**Technical note N°2/2023**

## Appendix H – Running Rigging Specification

**Spinnaker Roller position**

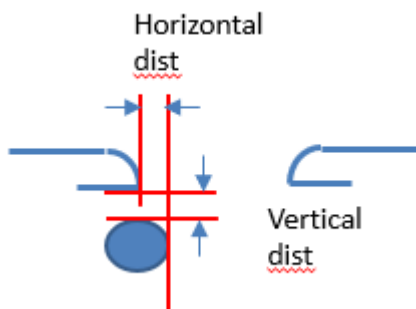
The Spinnaker roller position is defined as follows:

Maximum horizontal forward distance of the roller: 90mm

Maximum vertical lower distance: 110mm

Distances measured as per drawing below:
